**HYDROGEOLOGY OF SPRING, CAVE, DRY LAKE, AND DELAMAR VALLEYS
IMPACTS OF DEVELOPING SOUTHERN NEVADA WATER AUTHORITY'S CLARK, LINCOLN, AND
WHITE PINE COUNTIES GROUNDWATER DEVELOPMENT PROJECT
REBUTTAL TO SOUTHERN NEVADA WATER AUTHORITY'S EVIDENCE REPORTS**

Presented to the Office of the Nevada State Engineer

on behalf of Protestants White Pine County, Great Basin Water Network, et al.

August, 2017

Figure 1: Figure 4-2 from Drici et al. (2017) showing the ET-capture wells used to simulate SNWA's proposed pumping. The light green areas are areas of groundwater ET.

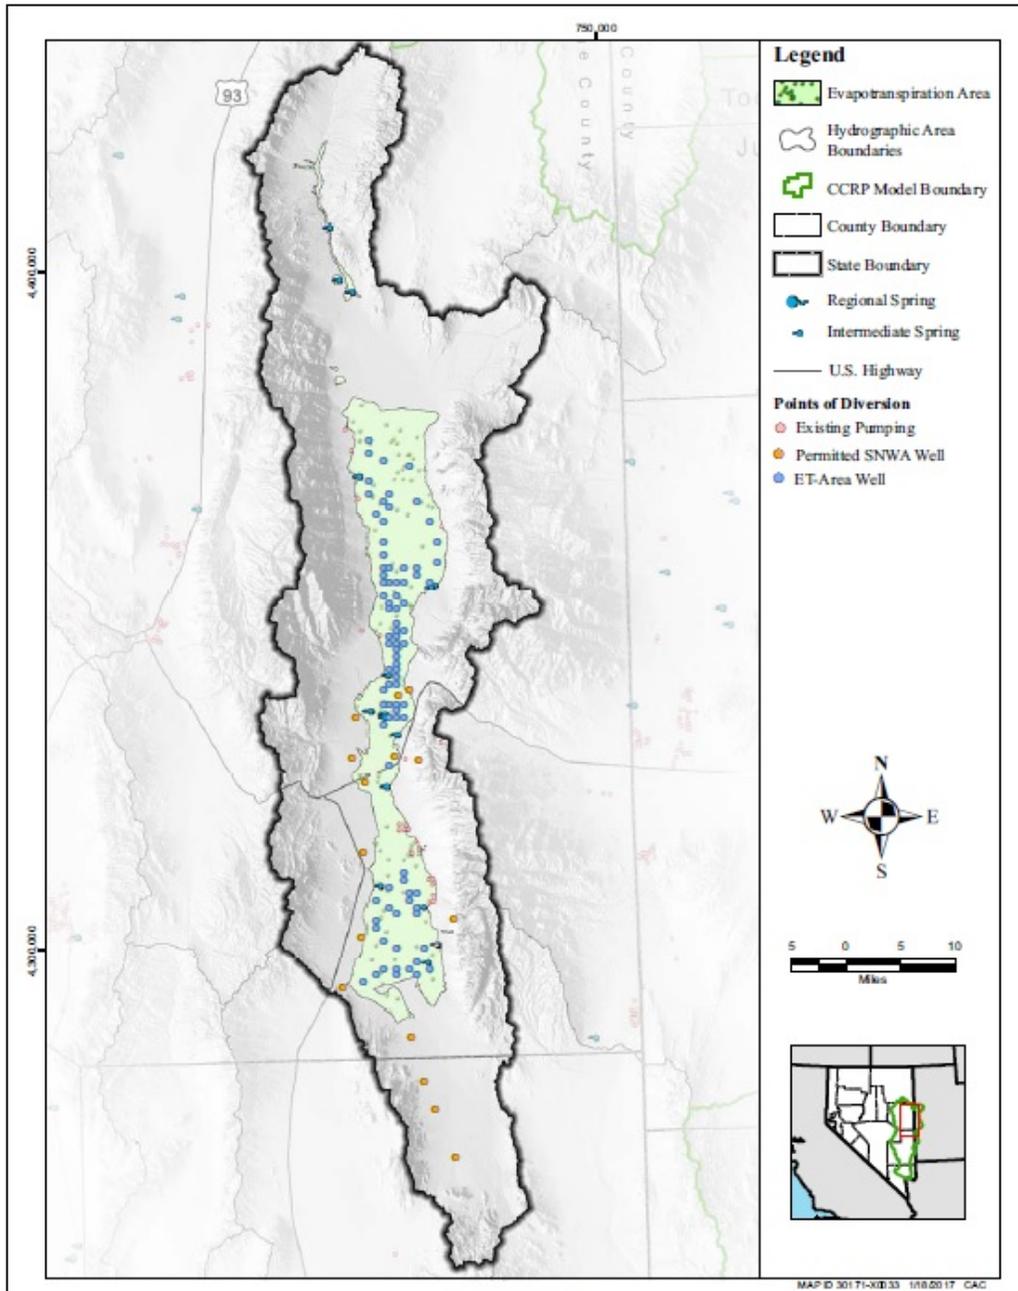
SNWA gave no attention to how this newly-created pumping regime would change the hydrologic or biological impacts analysis, to protecting the environment, or to how the stipulated agreement protecting groundwater resources would be implemented. Also, Drici et

al. (2017) does not discuss the depth of the pumping wells or the level at which they are screened. The report also does not provide the amount of water that each well would pump, other than to state that annual production volume of a given ET-capture well is based on its proximity to areas of high ET discharge.

SNWA states that “the scale of such a well field is not unusual for municipal water systems” (Drici et al. 2017, p 4-3). However, SNWA does not provide references or examples to support this statement. In my experience, this is much larger than most municipal water system well fields that sustainably operate.

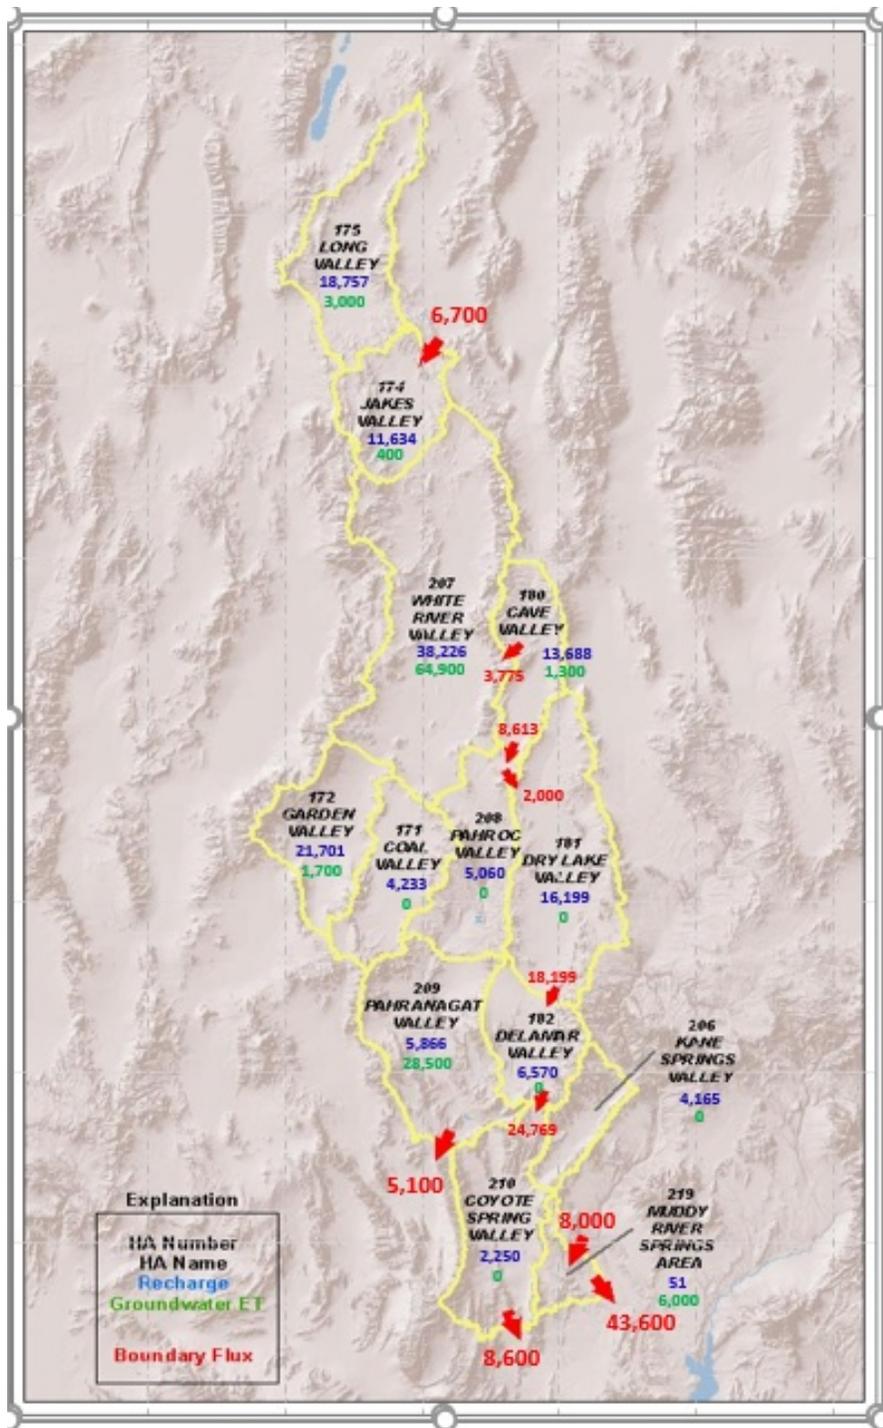
As noted, the NSE relied on this solver to estimate that the inflow of water to Coyote Spring Valley is 39,000 afa. As emphasized in the quote, this inflow rate is a pre-development flow that does not account for water use throughout the WRFS, including Pahrnagat Valley and White River Valley.

Stanka misinterprets Ruling 6255 in his conclusion. The ruling reasons that “because the basins share a unique and close hydrological connection and share virtually all of the same source and supply of water ... all five basins will be jointly managed” (Ruling 6254, p 24) and the “perennial yield of these basins cannot be more than the total annual supply of 50,000 acre-feet” (Id.). The ruling then notes that the “Muddy River and Muddy River springs also utilize this supply, and are the most senior water rights in the region, the perennial yield is further reduced to an amount less than 50,000 acre-feet” (Id.). Specifically, the water rights to the Muddy River are described in the Muddy River Decree. The NSE therefore linked the spring flow to the basins, and most of the inflow to those basins is the flow into Coyote Spring Valley from the upgradient basins in the WRFS.

Thus, there is no justification to remove Coyote Spring Valley and MRSA from the WRFS analysis. In fact, as just described, Order 1169 provides justification for adding Hidden Valley, Garnet Valley, and California Wash to the WRFS for this analysis.

Figure 4: Figure 5-11 from Stanka (2017) showing an example of supplemental pumping for Water Canyon Creek. See text for a discussion.

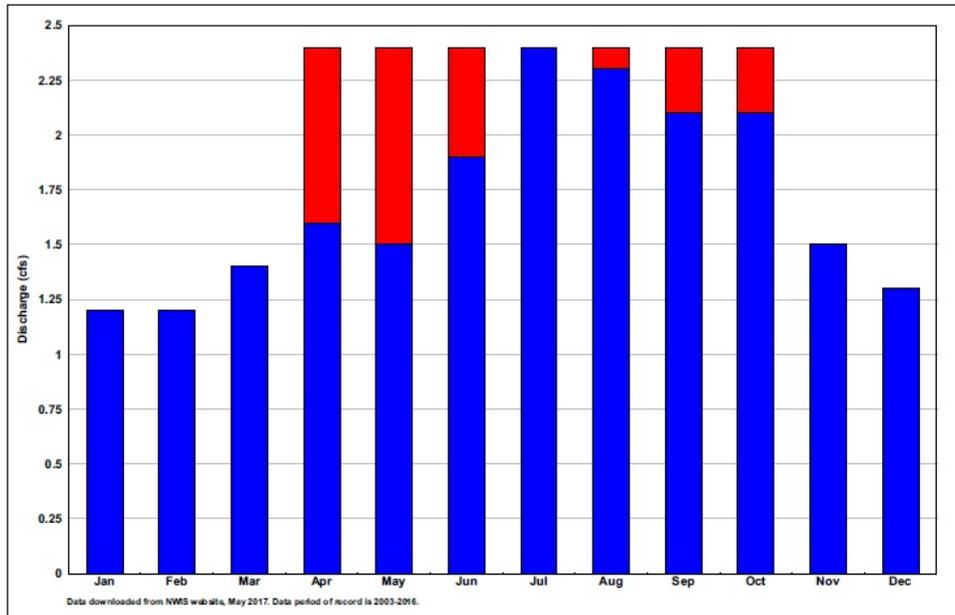
An accurate adjustment for supplemental pumping would require an estimate of how much of the year the primary right is used, followed by an estimate for how long the supplemental right is used to replace the primary right. There is no pumping data to use to estimate the amount of supplemental pumping (Stanka 2017, p 5-33), so he assumed that surface water would be fully appropriated based on the highest average monthly flow rate. He used monthly hydrographs from two streams that enter the valley, Water Canyon Creek near Preston (USGS Gage #09415515) and White River near Red Mountain (USGS Gage # 09415460) (Id.) (Figures 4 and 5) to assess the amount of water that would be appropriated and that would be supplemented with other water (spring or UG rights). He assumed the surface water source is fully appropriated, meaning that stream rights equal to the highest average monthly flow during irrigation season, and that surface water would be used preferentially to groundwater or spring water sources (Stanka 2017, p 5-33, -34, -36). Irrigation season is from April 1 to October 31 and he assumed a full irrigation season is used every year.

Water Canyon Creek has its highest average flow in July and the White River gage has its highest average flow in April and May. During those months, Stanka assumed the full gaged flow would be diverted, and during other, non-peak flow, months supplemental flow would be used to bring the streamflow to equal the full appropriation. The blue bars in Figures 4 and 5 represent the average flows by month, which were obtained from the appropriate USGS gage, and the red bars are the amount that Stanka determined would be supplemented, from UG or spring rights, to maintain a full irrigation season. He assumed that supplemental water would be available to the holder of these surface water rights

Figure 5: Figure 5-13 from Stanka (2017) showing an example of supplemental pumping for White River. See text for a discussion.

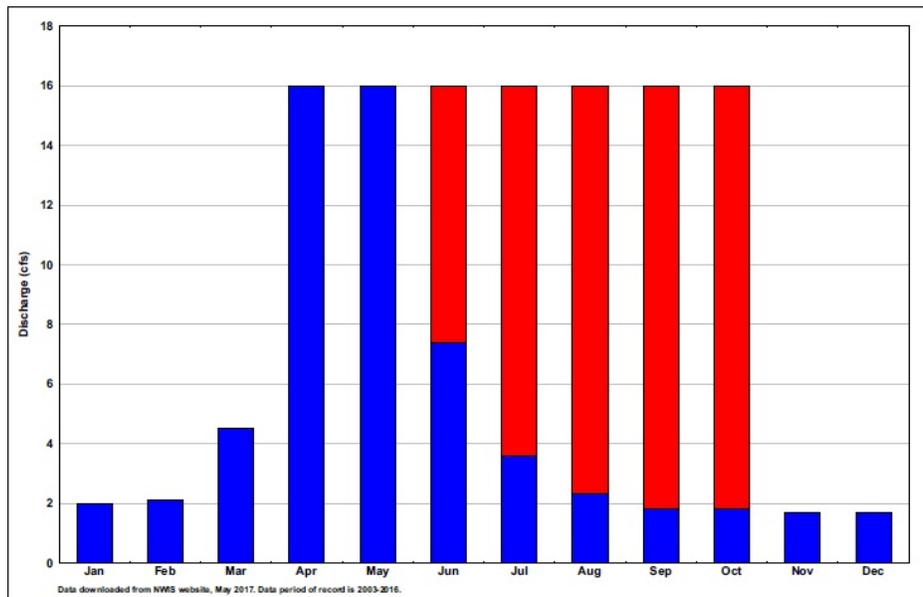
assumed the flows at these gages reflect surface water flows throughout the valley, even though that is unlikely.

Each gage is far above the valley bottom, meaning that diversions that could occur at the gage would be far above the areas of irrigation. The gage elevation and drainage area for Water Canyon near Preston are 6400 feet amsl and 11 square miles, and for White River near Red Mountain the gage elevation and drainage area are 6800 feet amsl and 28.2 square miles. The Water Canyon gage is high on an alluvial fan northeast of any irrigation on the WRV floor (Figures 6 and 7) into which it likely percolates and becomes recharge. The White River gage is at 6800 feet in the northwest part of WRV within the Toiyabe-Humboldt National Forest (Figure 8). Capturing surface water at the point of these gages would effectively take recharge from the WRV system.

Figure 13: Portion of Figure 1-1 from SNWA (2017b) showing SNWA's plan for monitoring in Spring Valley and surrounding valleys.

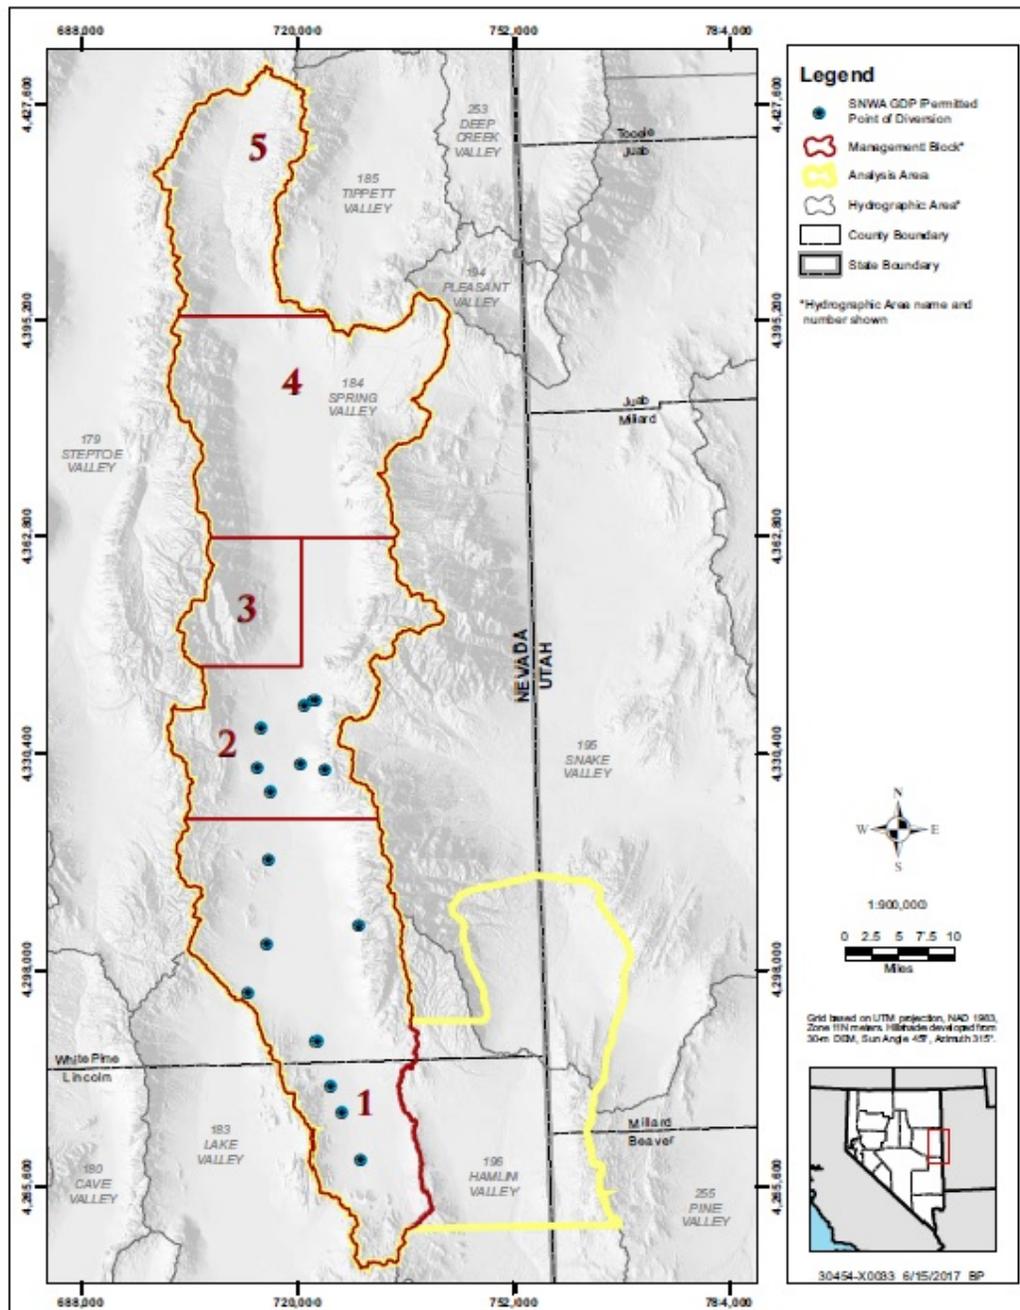
Outside of Spring Valley, SNWA's proposed 3M plan includes only part of northern Hamlin Valley and southern Snake Valley near Big Springs (Figure 13). It does not include Tippett or Pleasant Valley or consider any potential for the project to affect Gandy Warm Springs, meaning the SNWA monitoring plan does not consider interbasin connections found in BARCASS (Welch et al. 2008) and even SNWA's own modeling (Myers 2017).

Figure 14: Figure 2-1 from SNWA (2017b) showing the location of proposed monitoring for Spring Valley.

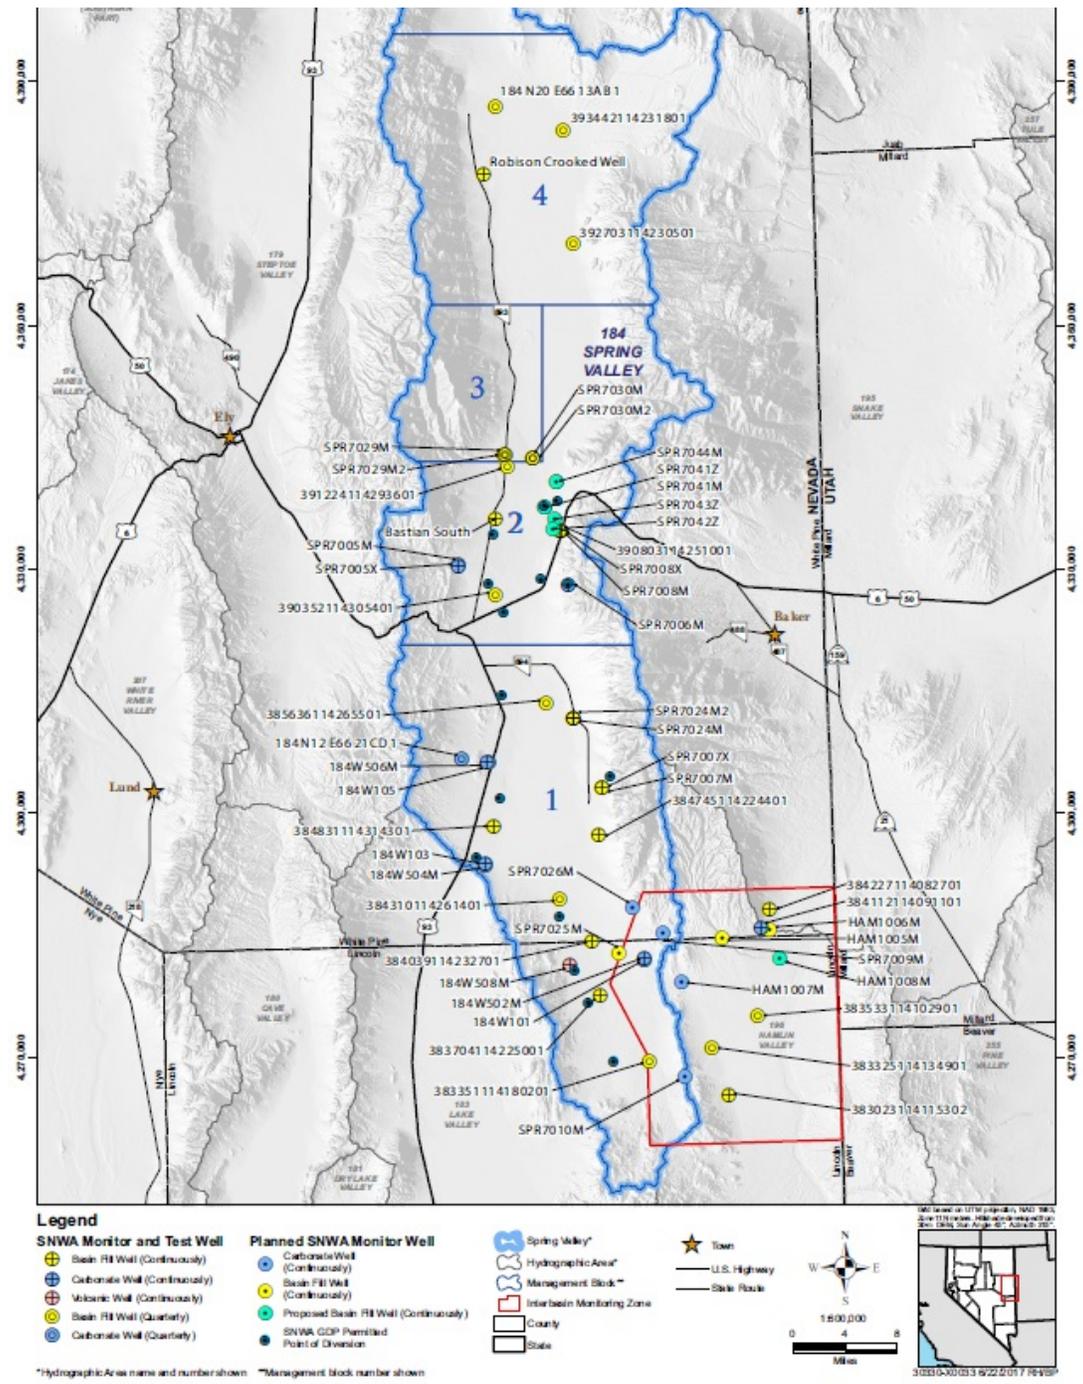
SNWA (2017b) Table 2-1 lists all the monitoring sites proposed for Spring Valley and Figure 2-1 (reproduced here as Figure 14) shows them. There is much less to that table than is apparent by simply considering its length, five pages long. There has been little added to it since 2011, the plan of which was reviewed by Myers (2017). Management area 1 would have 29 monitoring locations, many of which are already installed and several of which are simply spring flow monitoring or shallow piezometers. This is for an area that is about 30 by 10 miles. Management area 2 would have 26 monitoring locations, including several spring flow sites and piezometers. These also include as two locations various paired monitoring wells, such as SPR7005X and M or SPR7008X and M. This is for an area about 20 by 10 miles. Very little monitoring would occur north of the Cleveland Ranch which has only the sentinel wells and a spring proposed for Management Area 3 (Figure 14).

Figure 15: Portion of Figure 2-8 (SNWA 2017b) showing the SNWA PODs and proposed monitoring for the Cleveland Ranch/McCoy Creek Area.

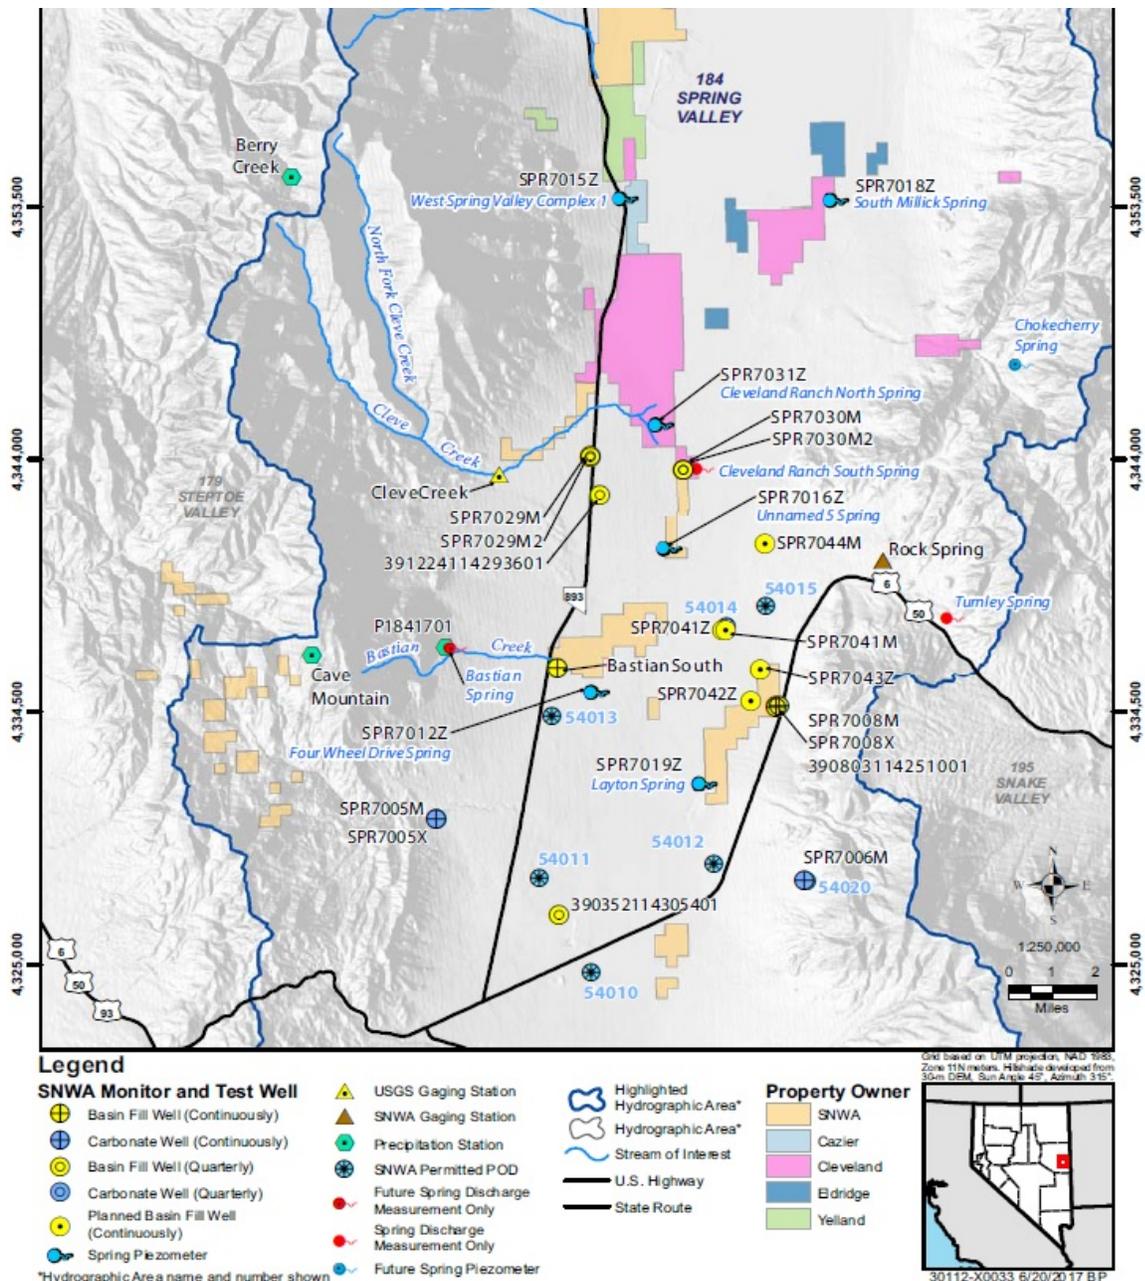
Figure 15 shows most monitoring proposed for Management unit 2, which lies south of the Cleveland Ranch (Figure 13). The sentinel wells just described would also be responsible for monitoring at least ten additional water rights, not on the Cleveland Ranch (Table 2-4, SNWA 2017b). Monitor well SPR7044M is an additional monitor well southeast of the Cleveland Ranch. (Id.) Piezometer SPR7012Z and SPR7016Z would monitor about 15 additional water rights. (Id.) At least eleven water rights would be monitored only at the right's POD. (Id.) Wells SPR7041M and Z, and piezometers SPR7042Z and SPR7043Z would monitor the Swamp Cedar area. (Id.) The monitoring near the Swamp Cedars area is intended to be related to the conditions of the area, such as tree density and health, rather than provide a trigger for management and mitigation (SNWA 2017b, p 2-51). As can be seen on Figure 15, these are the sole wells available for monitoring an area of about twelve by 24 miles, which is inadequate on its face.

Management Block 3, the Cleveland Ranch, would have five sentinel monitor wells near the southern end of Cleveland Ranch, as described on page 2-25 of SNWA (2017b) and shown in Figure 15. SNWA would monitor only three locations with these five wells because two locations include paired wells screened at different depths. These would be the northernmost monitoring wells and would be the sole monitoring points to detect drawdown signals for management areas 4 and 5. These three monitored locations are grossly insufficient because they are spread too far and would monitor aquifer layers that are much too thick to adequately
